UNITED STATES PATENT AND TRADEMARK OFFICE

APPLICATION NO.	FILING DATE	FIRST NAMED INVENTOR	ATTORNEY DOCKET NO.	CONFIRMATION NO.
10/803,973	03/19/2004	Tse-Hsiang Hsu	3722-0185PUS1	6496
2292	7590	06/08/2006	EXAMINER	
BIRCH STEWART KOLASCH & BIRCH PO BOX 747 FALLS CHURCH, VA 22040-0747			TON, TRI T	
			ART UNIT	PAPER NUMBER
			2877

Office Action Summary

DETAILED ACTION

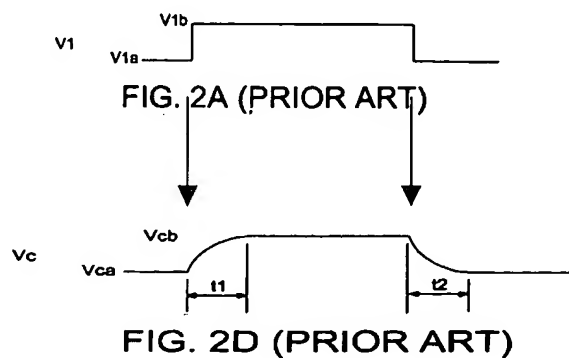
Priority

1. Receipt is acknowledged of papers submitted under 35 U.S.C. 119(a)-(d), which papers have been placed of record in the file.
